June 19, 2020

Version 3

Safety Recall: 2019 RLX Fuel Pump Motor

Supersedes B20-028, dated June 5, 2020, to revise the information highlighted in **yellow**

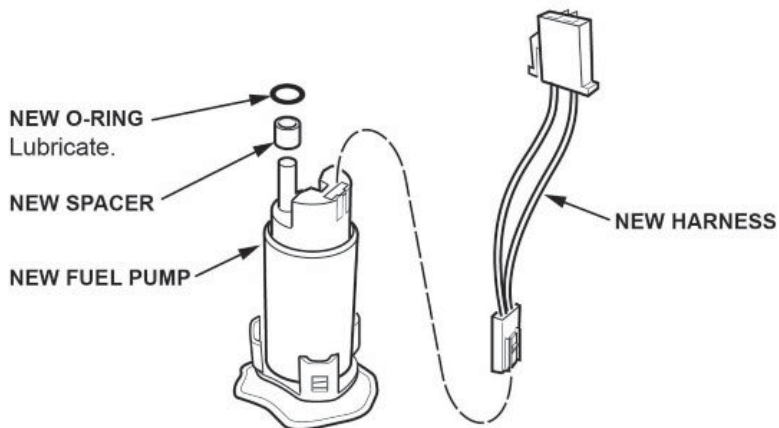
- **The O-ring must be installed on the pump as shown, not on the fuel filter side.**
- Coat the O-ring with clean engine oil; do not use any other oil or fluid.
- Do not pinch the O-ring during installation.
- When connecting the wire harness, make sure the connection is secure and the connectors are firmly locked into place.
- Use all of the new parts supplied in each replacement kit.

9.2. **Place the fuel pump on a bench, then install the filter to the fuel pump.**
